LINCOLN CITY/LANCASTER COUNTY PLANNING STAFF REPORT

for May 25, 2005 PLANNING COMMISSION MEETING

P.A.S.: Four Stones Community Unit Plan **REVISED**
Co. Special Permit #04055, Preliminary Plat #04025

PROPOSAL: A community unit plan and preliminary plat for fourteen acreage residential units with four outlots (previously 31 lots).

3 of 5

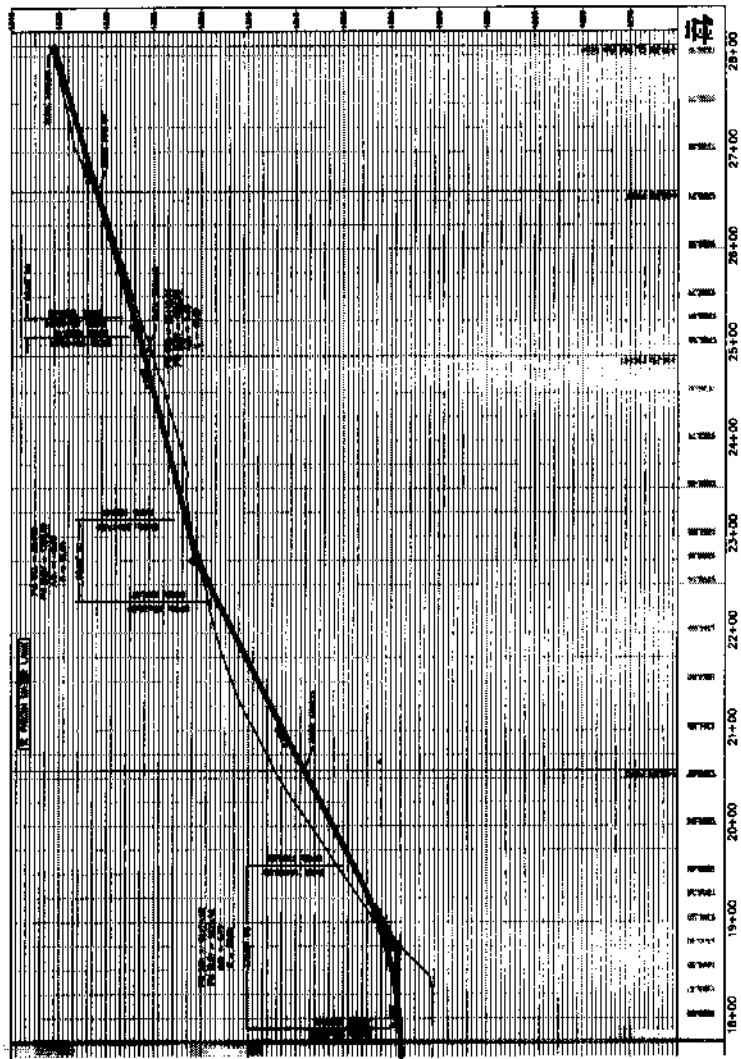
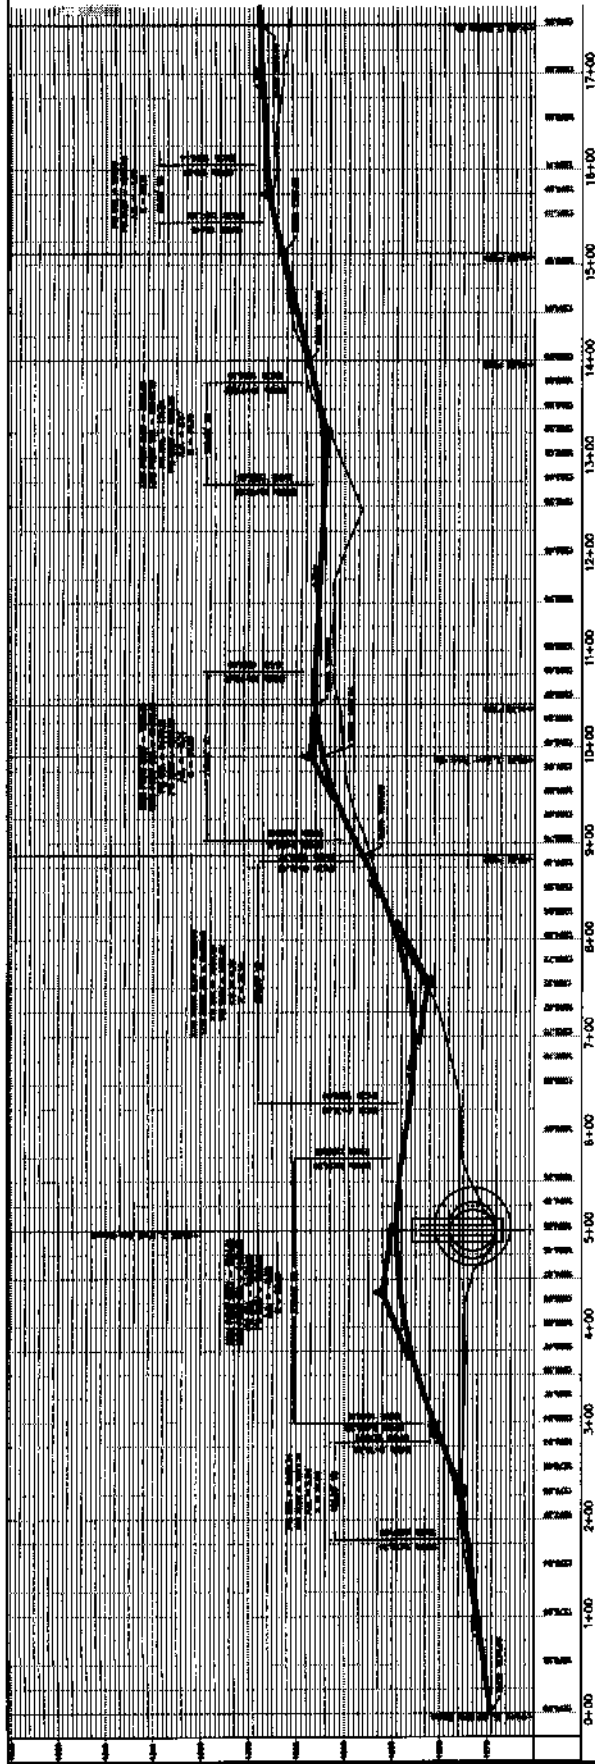
- 1.6 Sheet 3 of 5 should be changed to reference street grades, not paving.
 - 1.7 Show the easements requested by Norris Public Power.
 - 1.8 Complete a subdivision permit for the existing farmstead split on S.W. 29th Street prior to approval of final platting.
